LAND USE APPLICATION SUMMARY

Property Location: 416 35th Avenue Northeast
Project Name: DLTl Ventures LLC
Prepared By: Aaron Hanauer, City Planner, (612) 673-2494
Applicant: DLTl Ventures, LLC
Project Contact: Tanek Architecture Design, Ken Piper
Request: To allow a recycling facility in the I2/Medium Industrial District.
Required Applications:

Conditional Use Permit	To allow a recycling facility in the I2/Medium industrial District.
Site Plan Review	To allow for a recycling facility.

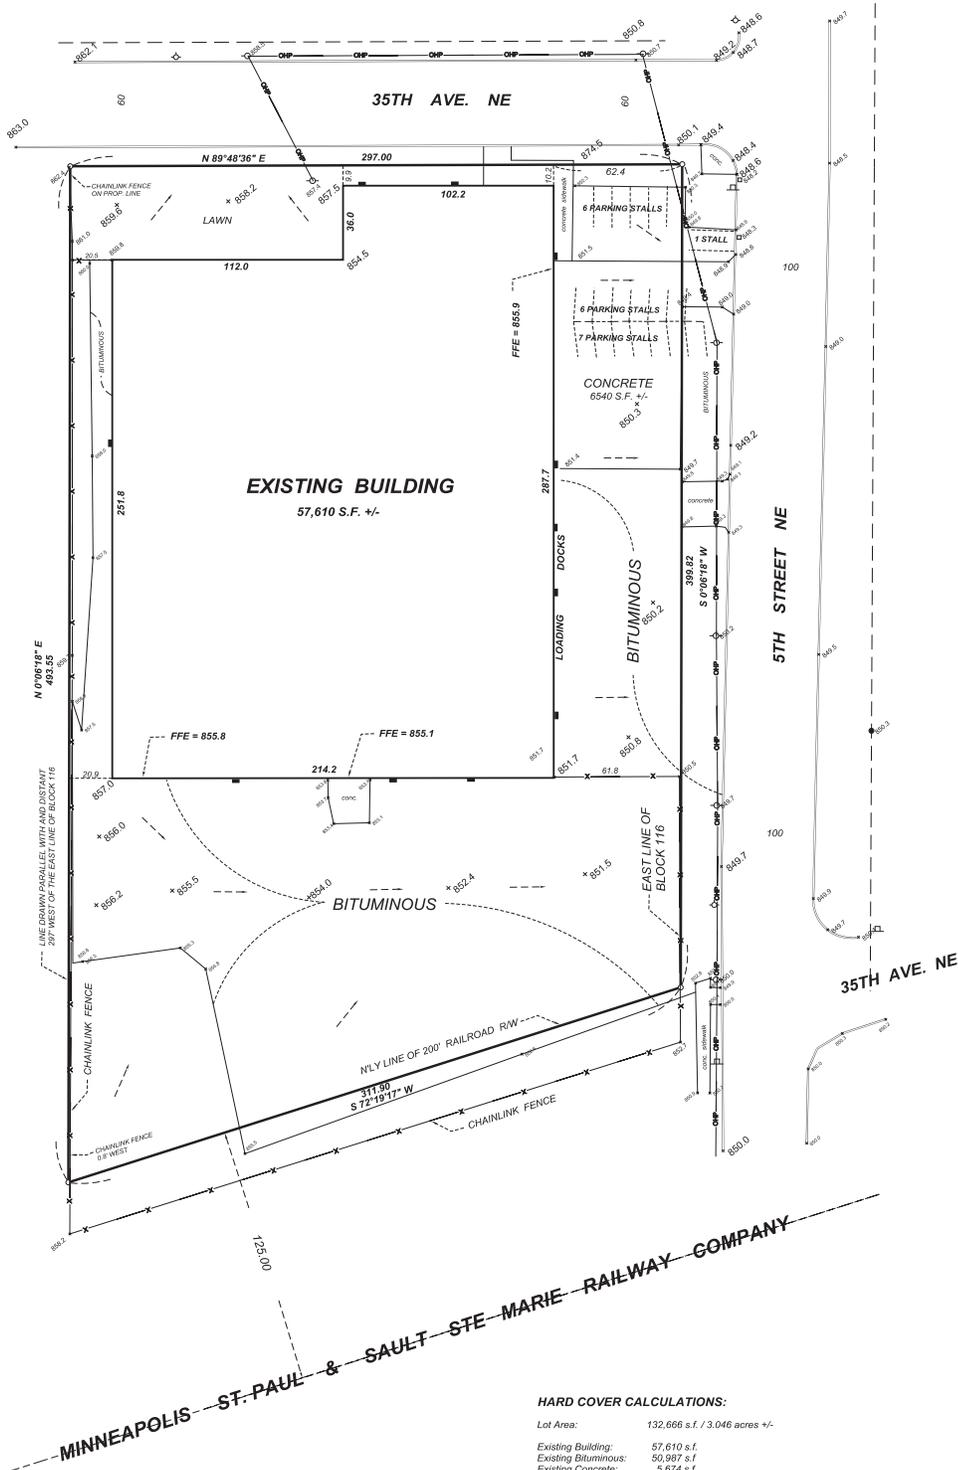
- Stormwater Management: Please identify the square footage of the area proposed to be disturbed with the project, and the existing and proposed impervious square footages within the disturbed area. Please also identify on the plan view, the proposed extents of the disturbed area.

- Based on the description of the use of the site, an industrial stormwater permit from the MPCA may be required. Please provide documentation of any existing permits or obtain the necessary permits. If it has been verified that permitting is not required, please provide supporting documentation.

- Erosion Control: It is unclear the extents of any proposed improvements on the site. Please note, if more than 5,000 square feet of 500 cubic yards of land is disturbed an erosion and sediment control plan in conformance with Chapter 52 of the Minneapolis Code of Ordinances is required for the project. Please provide the appropriate erosion and sediment control measures and details on the plan, if necessary.

- Based on viewing the property on Google Streetview you should be able to provide ADA parking with an access aisle within the parking lot, using parking stall number 5 & 6 with accessible route with 1:20 maxi slope to main entrance door. See attachment for example plan.

PARTIAL SITE PLAN
1/16" = 1'-0"

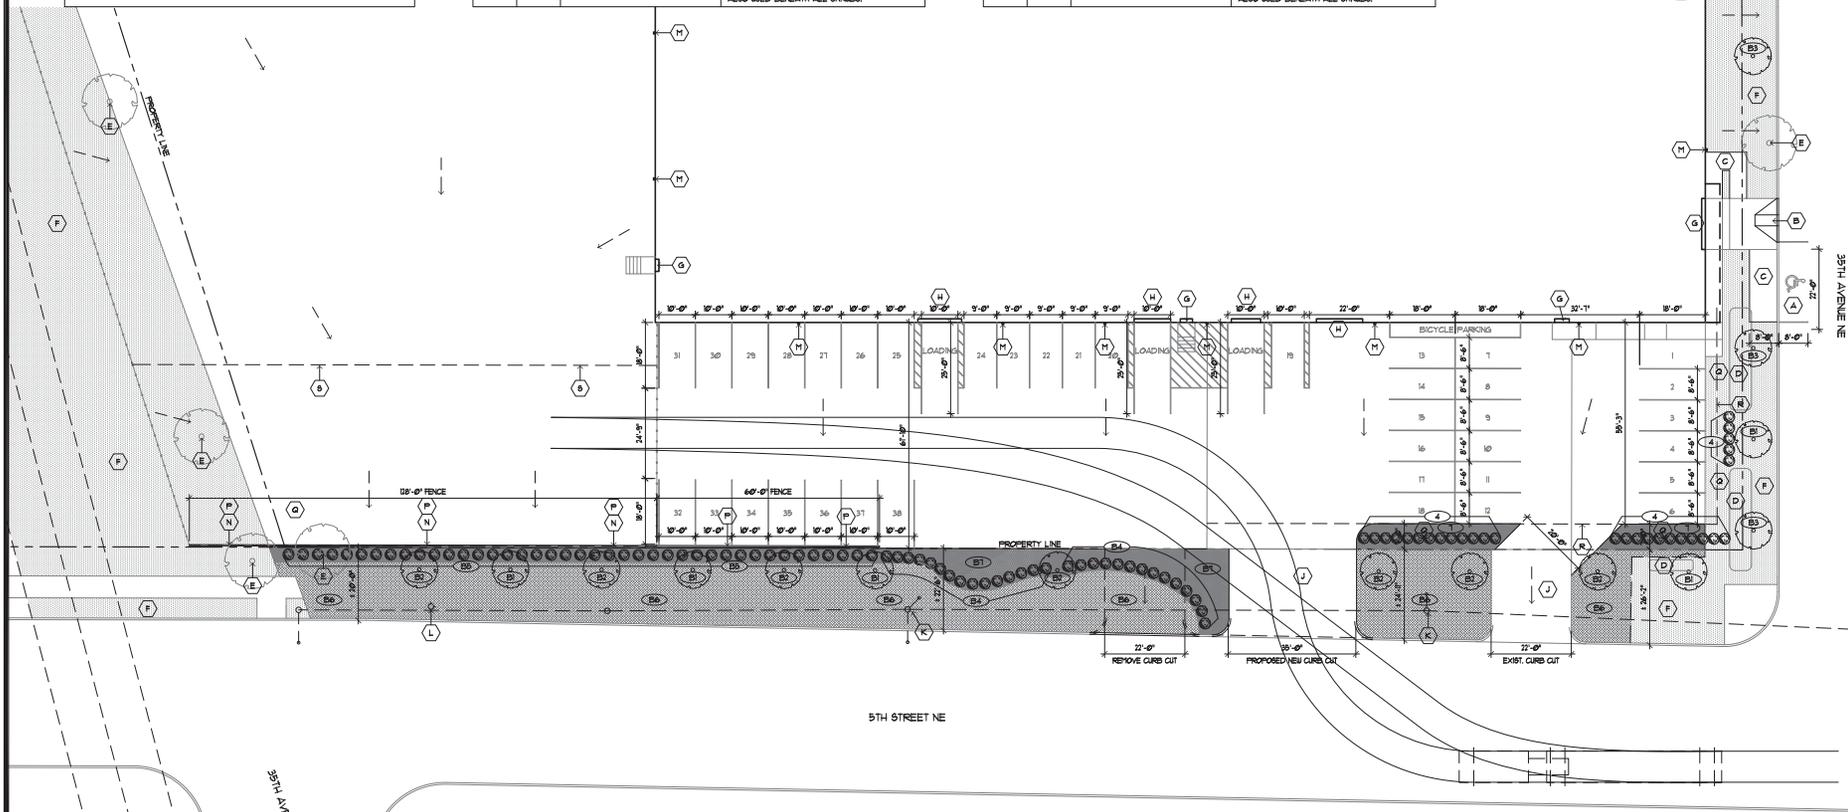
- The project has a chain link fence along a portion of 5th Street Northeast and along the southern property line. This fence has a barbed wire top. The applicant is proposing to remove the chain link fence along 5th Street Northeast. CPED is recommending that the barbed wire fence along the southern property line be removed to comply with Section 535.430-Fence design requirement that barbed wire not be located within one hundred (100) feet from a residence district. The applicant is proposing to replace the existing fence along 5th Street Northeast with a decorative wood or composite screening fence that is six feet in height for 188 linear feet along 5th Street Northeast. Staff is recommending that the applicant submit details of the proposed fence along 5th Street Northeast prior to building permit issuance for CPED review and approval to ensure compliance with Section 530.160-General landscaping and screening.

- The applicant is proposing outdoor storage along the western interior property line. This area has street frontage along 35th Avenue North. There is a landscaped yard along 35th Avenue Northeast that is 47 feet wide. However, there is currently no screening. To comply with Section 550.280, CPED is recommending that screening not less than 6 feet in height and not less than 95 percent opaque be provided to screen the storage area from 35th Avenue Northeast. The screening shall be in compliance with the design requirements in Chapter 530, Site Plan Review.

- The applicant is also proposing to have outdoor storage along 5th Street Northeast that is within 300 feet of a residential district. The proposal of a 6-foot high decorative screening fence along 5th Street Northeast and plantings in front of that will comply with the screening requirement along the eastern property line. However, the applicant is not proposing any screening along the southern property line. The outdoor storage area is visible from 35th Avenue Northeast for those that are traveling northbound. To meet the intent of this requirement, CPED is recommending that the applicant provide screening not less than 6 feet in height and not less than 95 percent opaque along the southern property line that is within 100 feet of the residential district.

- **Landscaped yard requirement for parking and loading abutting a residential zoning district (along 5th Street Northeast):** As required by Section 530.170- Parking and loading landscaping and screening, an onsite landscaped yard that is at least seven feet in width is required when abutting a residential zoning district. Along the eastern property line (5th Street Northeast), the applicant is proposing to add a 7-foot wide landscaped yard onsite for the off-street parking area at the northern end of the site and to landscape the entire 5th Street Northeast boulevard.

- **A minimum of one tree for every 25 linear feet of parking or loading fronting a street (5th Street Northeast and 35th Avenue Northeast):** As required by Section 530.170-Parking and loading landscaping and screening, not less than one tree is required for each 25 linear feet or fraction thereof of parking and loading area lot frontage. The applicant is not proposing to plant trees onsite along 5th Street Northeast or 35th Avenue Northeast. Alternative compliance is required. The intent of this requirement is to support and enhance the City of Minneapolis tree canopy and the benefits trees bring to a city including reducing the heat island effect. The applicant is proposing to plant eight trees for 231 feet of street frontage along 5th Street Northeast. This provides a tree for every 29 feet. If the tree planting plan was slightly revised, the proposal would be able to meet the intent of the one tree for every 25 linear foot requirement. Therefore, CPED is recommending the applicant plant one tree for every 25 linear feet of parking or loading fronting 5th Street Northeast within the public right-of-way.

4. To meet the intent of Section 530.170-Parking and loading landscaping and screening, one tree shall be planted for every 25 linear feet of parking or loading fronting 5th Street Northeast within the public right-of-way.

13. To comply with Section 550.280-Enclosed building requirement, screening not less than 6 feet in height and not less than 95 percent opaque shall be provided in front of the storage area along 35th Avenue Northeast. The screening shall be in compliance with the design requirements in Chapter 530, Site Plan Review.
